METROPOLITAN GOVERNMENT OF NASHVILLE AND DAVIDSON COUNTY

STAFF RECOMMENDATION
1515 McKennie Avenue
January 21, 2015

Application: New construction-infill
District: Eastwood Neighborhood Conservation Zoning Overlay
Council District: 06
Map and Parcel Number: 08302023500
Applicant: Lynn Taylor, designer
Project Lead: Sean Alexander, sean.alexander@nashville.gov

Description of Project: The applicant proposes to construct a one and one-half story two-family dwelling on an interior lot.

SITE PLAN

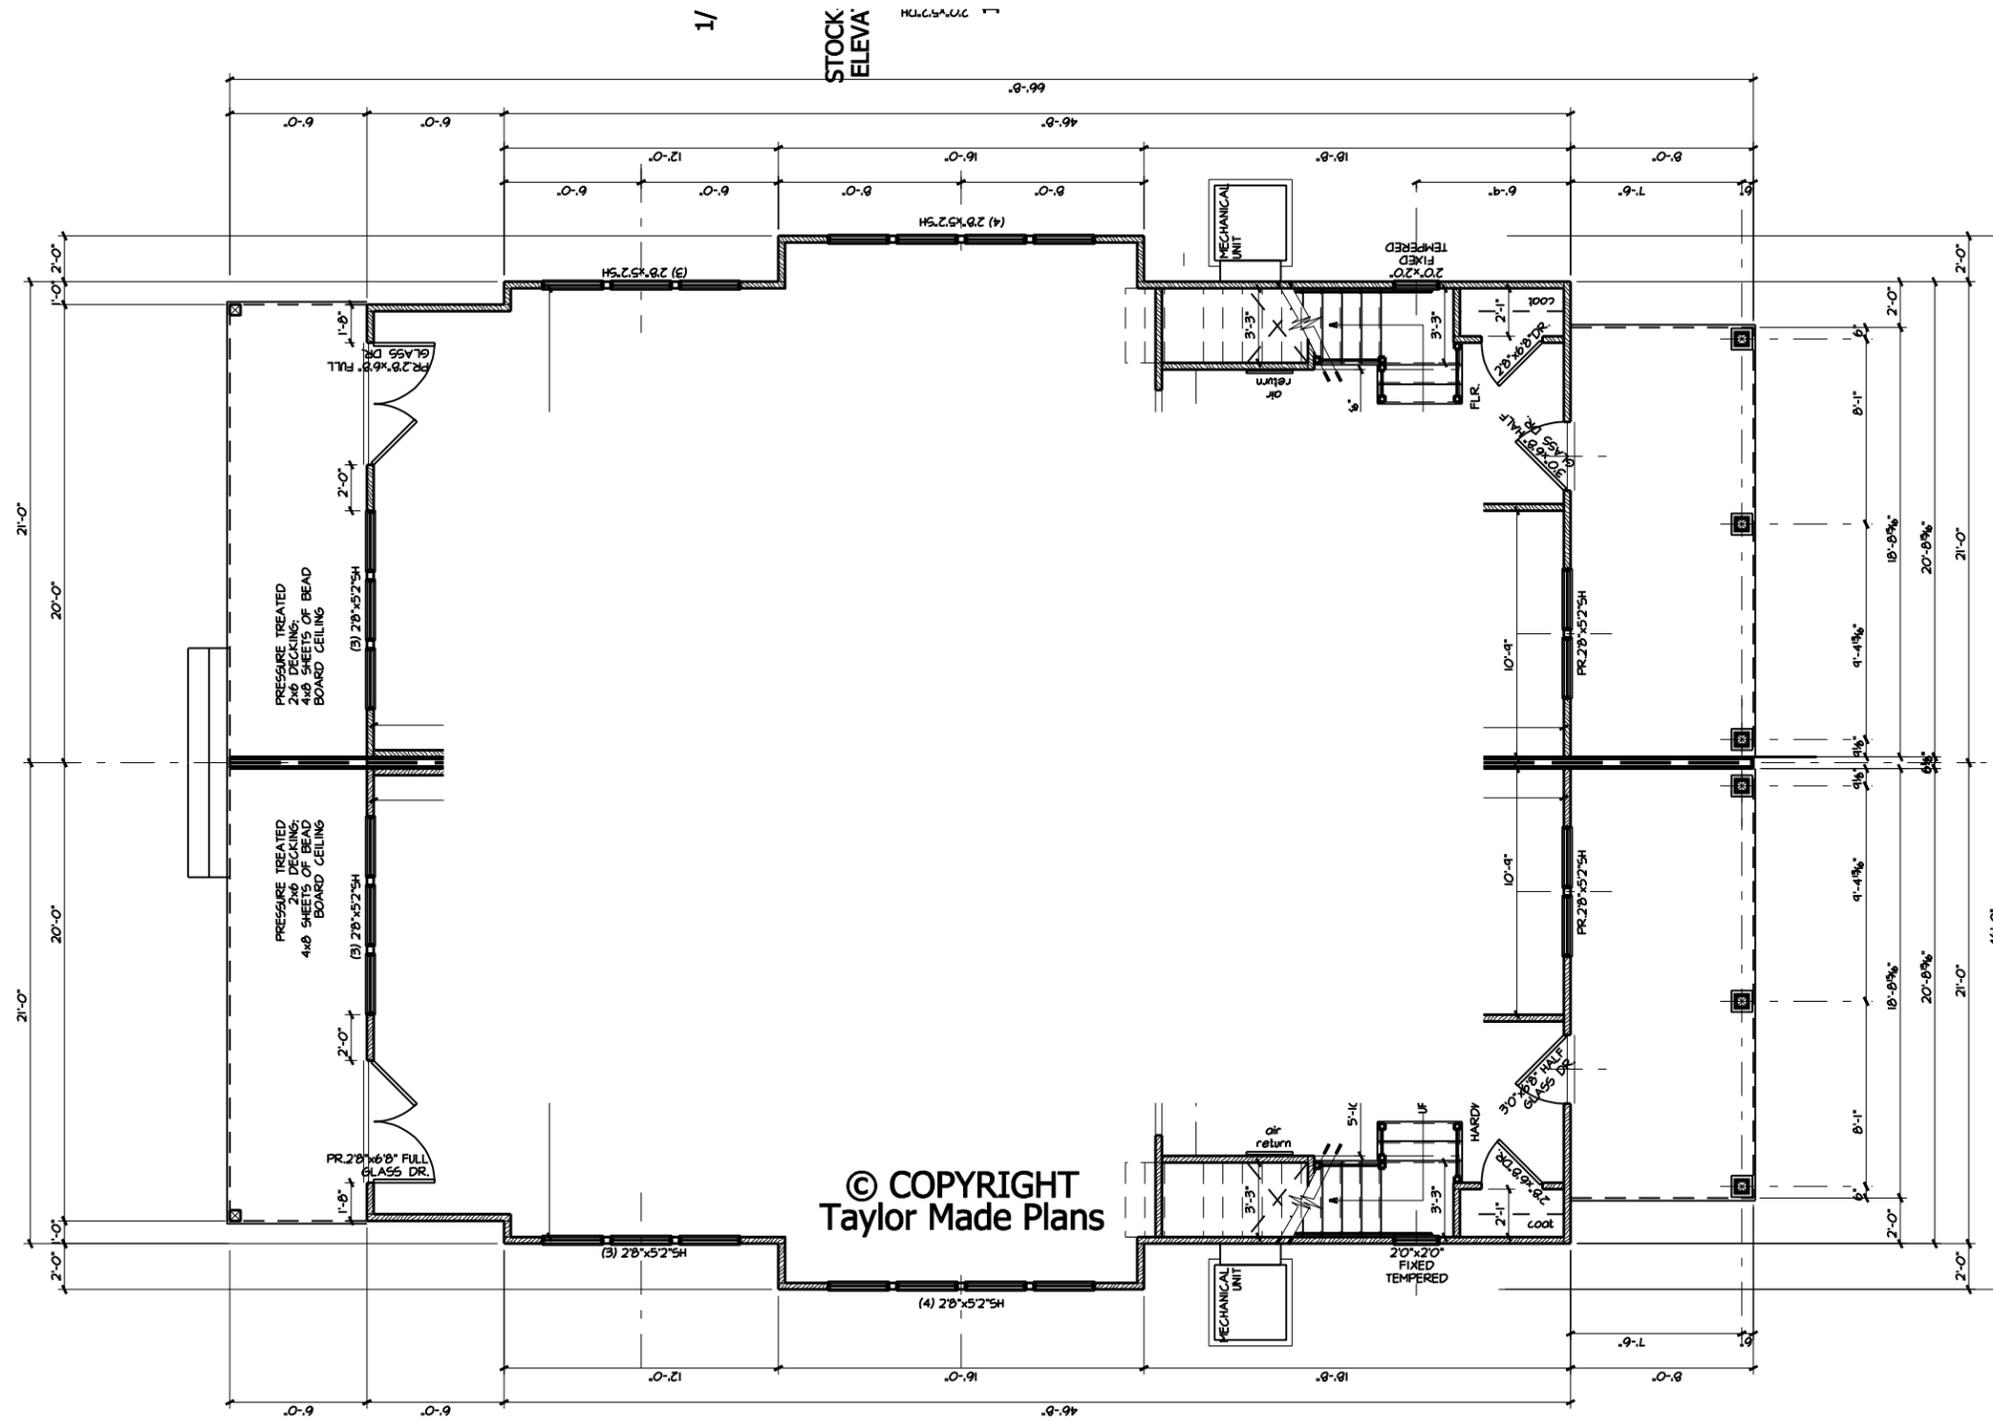
The building will be a duplex, with a shared full-length porch across the front façade which would be oriented to the street directly, matching the orientation of the established pattern of the street. No walkways or parking is shown on the plans. Staff recommends that a walkway be added to connect the front porch to the street, as is typical of the surrounding historic context in order to meets section II.B.1.f.

1 REAR ELEVATION
SCALE: 1/4" = 1'-0"
STOCK# C1011
ELEVATION#1

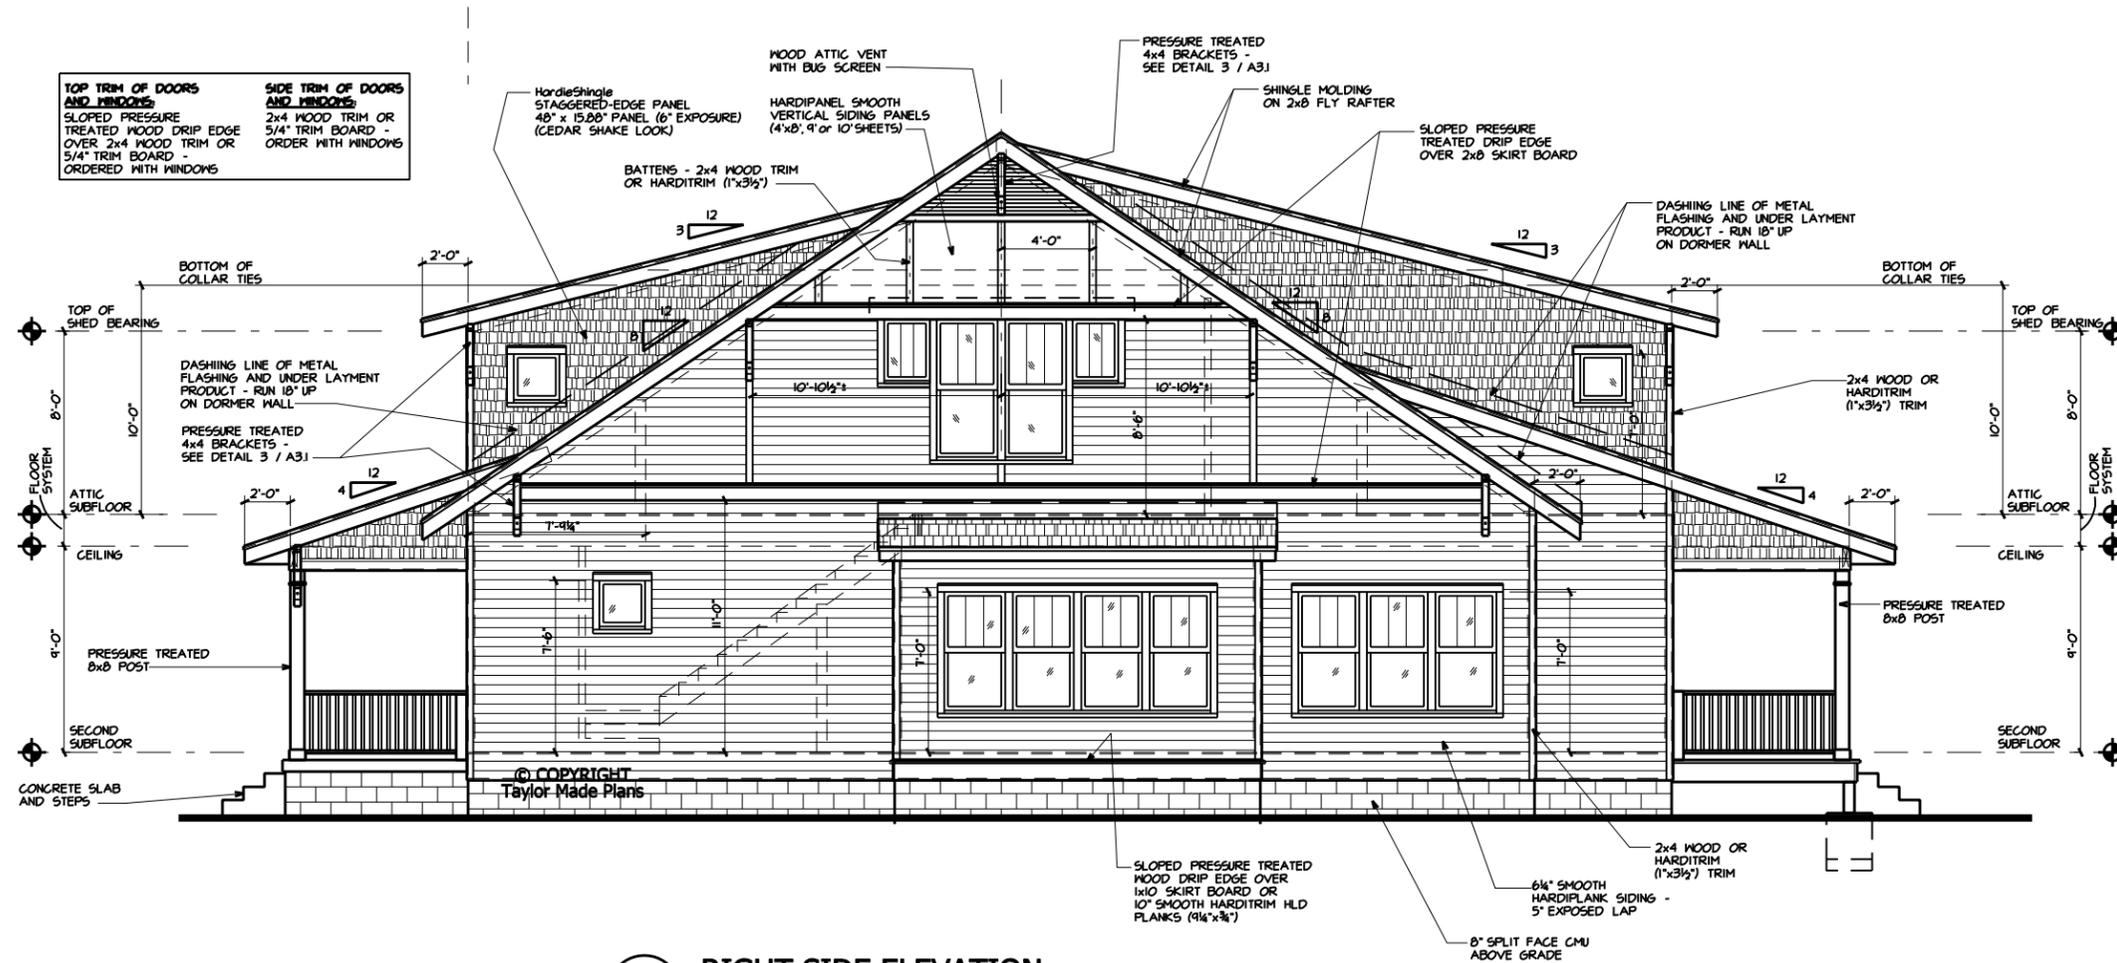
The primary roof will be a side-facing gable with a pitch of 8:12, with shed-roofed porches and dormers on both the front and rear. The porch roofs will have a pitch of 4:12 and the dormers will have a pitch of 3:12. The dormers will be very similar in size, extending nearly the full width of the building and with their “front” walls stacked directly over the first story walls below. The sides of the front dormer will sit in three feet (3’) from the primary side walls and the sides of the rear dormer will sit in two feet (2’) from the primary side walls. These proportions are appropriate on the rear because is not greatly visible from the street. However, a large single front dormer is not typical of dormers on historic houses.

The location of the HVAC would be on the sides of the building near the front. Staff asks that the HVAC be located on the rear façade or on a side façade beyond the midpoint of the house in order to meet section II.B.1.i.

As a condition of approval, Staff recommends that the front dormer be set back two feet (2’) from the primary front wall and divided into two separate dormers, each no greater than one-third of the width of the building overall.

2 RIGHT SIDE ELEVATION
SCALE: 1/4" = 1'-0"

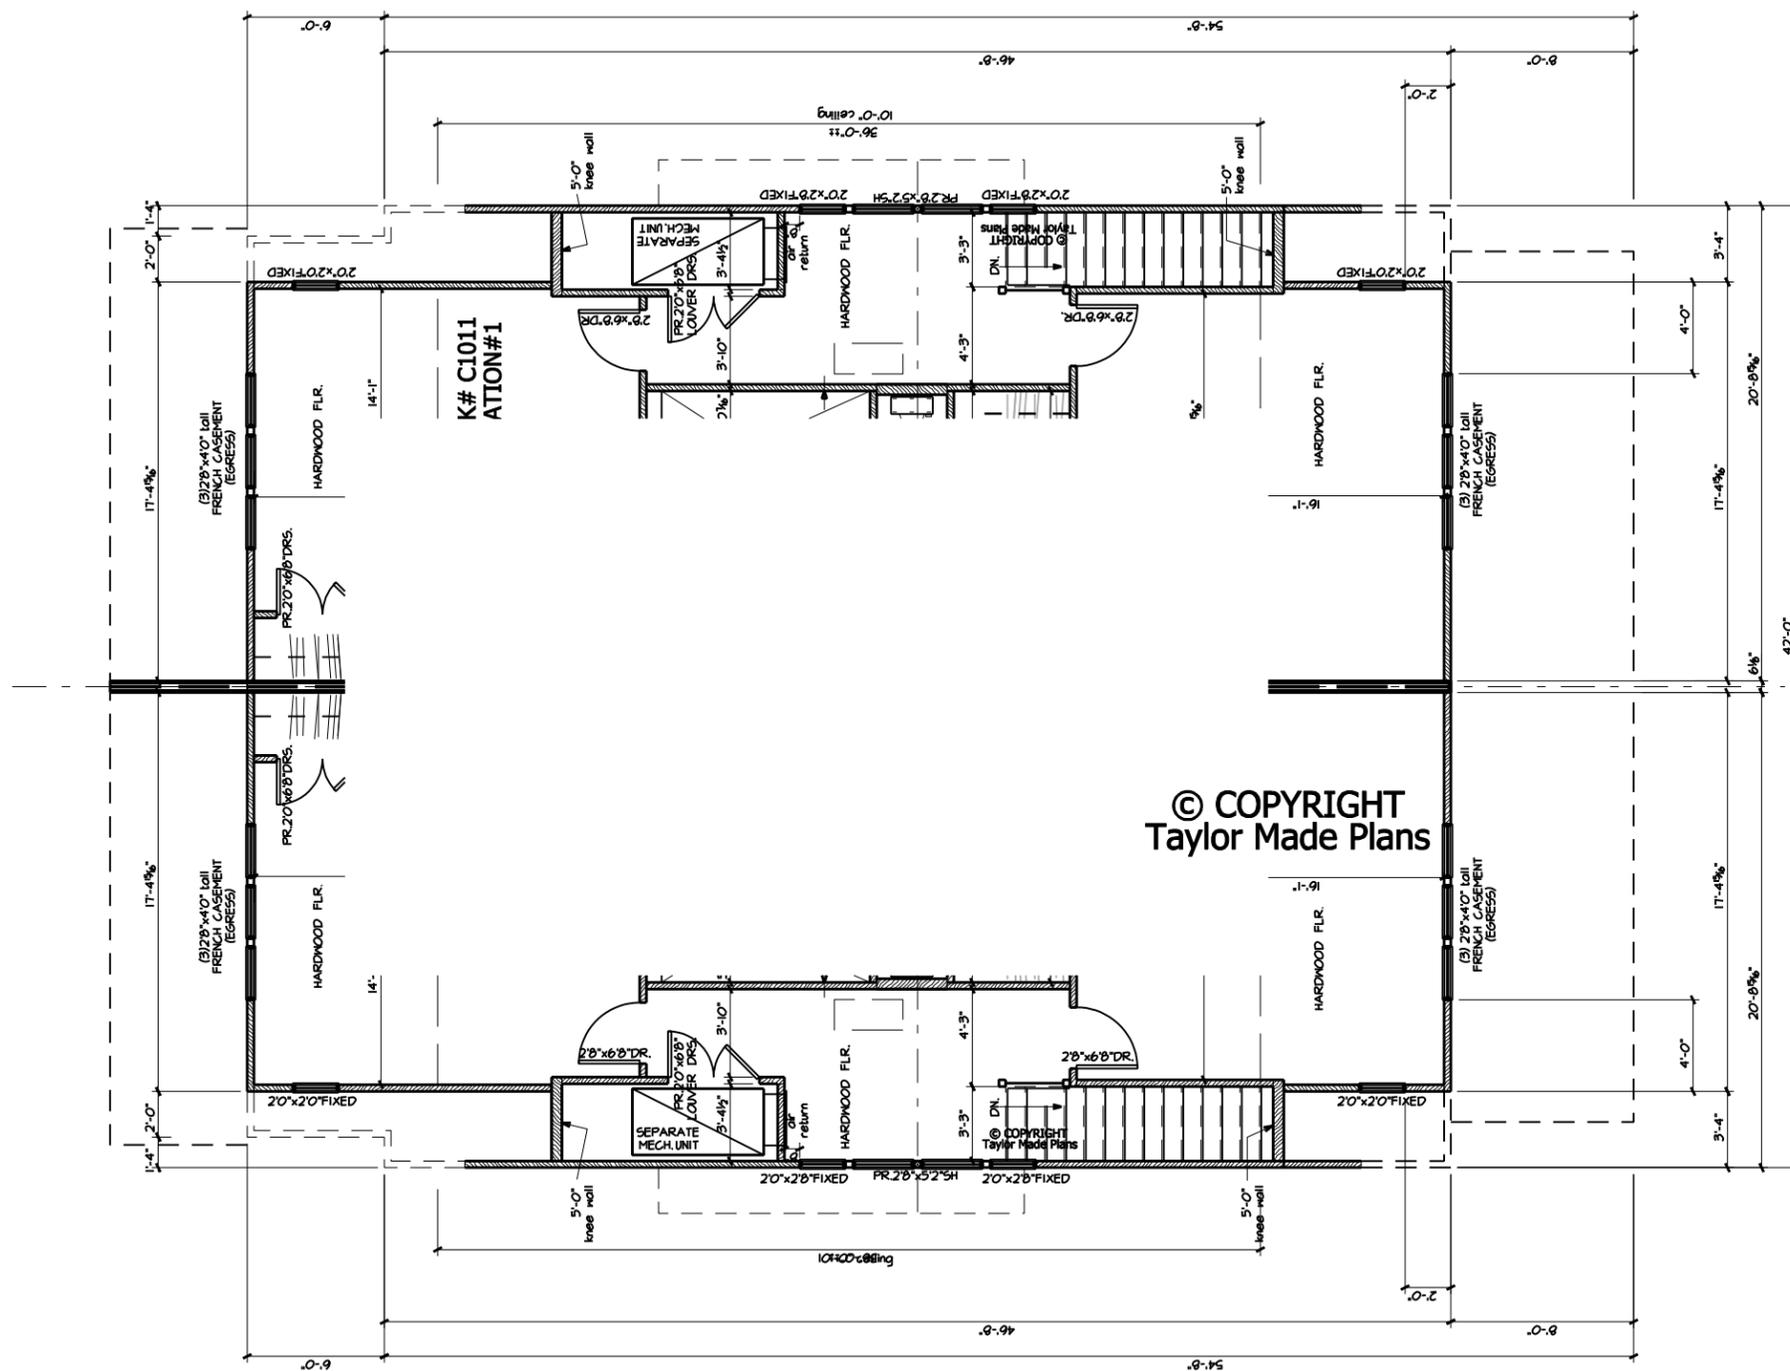
The proposed new building will be one and one-half story tall, with a ridge height of twenty-nine feet, nine inches (29'-9") above grade. The building will have an eighteen inch (18") tall foundation and a primary eave height of twelve feet (12') above grade.

The houses on the 1500 block of McKennie Avenue are all between seventeen feet (17') and twenty-two feet (22') tall, however they are not historic. Looking to the 1400 block of McKennie for comparison, Staff finds that the height of the proposed house would be greater than the closest historic context. For comparison, the historic houses on the 1400 block are between twenty feet (20') and twenty-seven feet (27') tall. Staff recommends that the height of the building is reduced by two feet (2') to be more in keeping with the nearest historic context.

The building will be forty-six feet (46') wide in total, with a forty-two feet (42') primary massing with projecting bays adding two feet (2') on each side. The projecting front porch will be forty feet (40') wide, stepping in one foot (1') from the primary massing on each side.

Staff recommends that the width of the proposed building be reduced to forty feet (40').
